**BOARD OF ZONING ADJUSTMENT  
STAFF REPORT****Date: November 2, 2015****CASE NUMBER**

6007

**LOCATION**2354 & 2410 Eloong Drive  
(East terminus of Eloong Drive)**VARIANCE REQUEST****PARKING SURFACING AND ACCESS AND  
MANEUVERING:** Surfacing Variance to allow gravel  
parking and access and maneuvering surfacing.**ZONING ORDINANCE  
REQUIREMENT****PARKING SURFACING AND ACCESS AND  
MANEUVERING:** The Zoning Ordinance requires  
asphalt, concrete, or an approved alternative paving surface  
for parking and access and maneuvering areas.**ZONING**

SITE PLAN

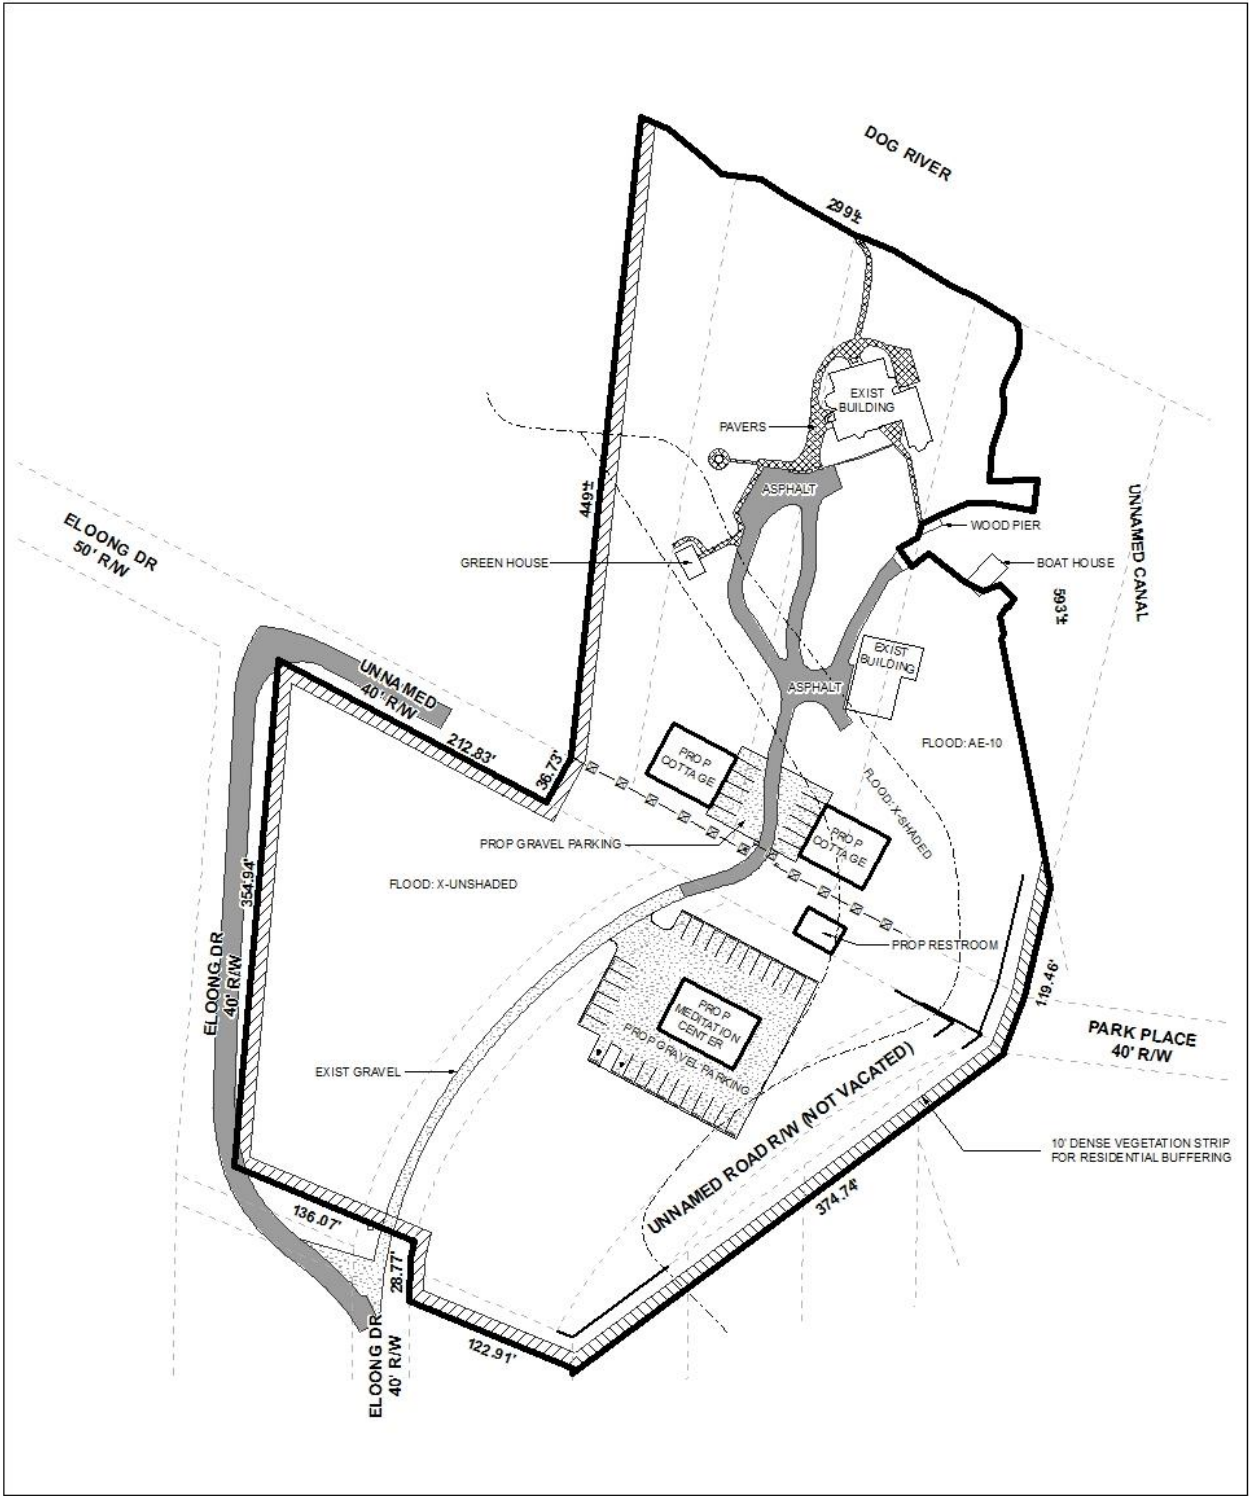
The site plan illustrates existing asphalt driveways and an existing gravel driveway on the site, however it should be noted that none of the existing driveways meet the minimum required width of 24' for two-way traffic. Per Fire Department comments, the site plan should be revised to reflect 26' wide driveways paved with asphalt or concrete, unless the surfacing variance is approved.

Because the site is transitioning from a residential use to a commercial use, the site should be required to fully comply with all landscaping and tree planting requirements. The site plan indicates that the site will have ample amounts of landscape area; however no trees are illustrated on the site plan. The applicant states that there are 24" or larger trees on the site; but none of them are illustrated on the site plan. The site plan should be revised to reflect this requirement, if approved.

The site plan depicts a 10' wide vegetated residential buffer around the perimeter of the site, but as none of the existing vegetation is illustrated on the site plan, staff is unable to verify if this buffer is adequate to comply with Section 64-4.D.1. of the Zoning Ordinance.

The site plan provides parking calculations stating that parking will be provided for 8 dwelling units, and a 1 parking space per 100 square feet ratio was used to determine parking required for the meditation center. It should be noted that because of the religious nature of the proposed facility, the parking requirements should be based on the occupancy of the structure. If the structure will have a total occupancy load of more than 50 individuals (excluding hallways and bathrooms), the International Building Code classifies the proposed use as assembly. To determine the amount of required parking, the applicant should provide a floor plan of the proposed 2,400 square foot meditation center. The floor plan should illustrate restrooms and hallways, and their square footage. It should also illustrate areas used for meditation and if there

No dumpsters are illustrated on the site plan, nor is a note stating the site will use curb-side pickup. It should be noted that any dumpsters on site should be connected to sanitary sewer and have a dumpster enclosure compliant with Section 64-4.D.9. of the Zoning Ordinance.

- 1) provision of the floor plan of the proposed 2,400 square foot meditation facility with the occupancy loads provided (excluding hallways and bathrooms);
- 2) revision of the driveways to reflect a minimum width of 26' per Fire Department comments;
- 3) illustration of all trees 24" or larger on the site with species identified;
- 4) illustration of full compliance with tree planting and landscape area requirements; and
- 5) depiction of vegetation making up proposed residential buffer to insure it complies with Section 64-4.D.1. of the Zoning Ordinance;
- 6) compliance with Engineering comments (*If the aggregate surfacing is approved for use the applicant will need to have the following conditions met: A. Submit and receive a Land Disturbance Permit for the proposed site development through Central Permitting.*)
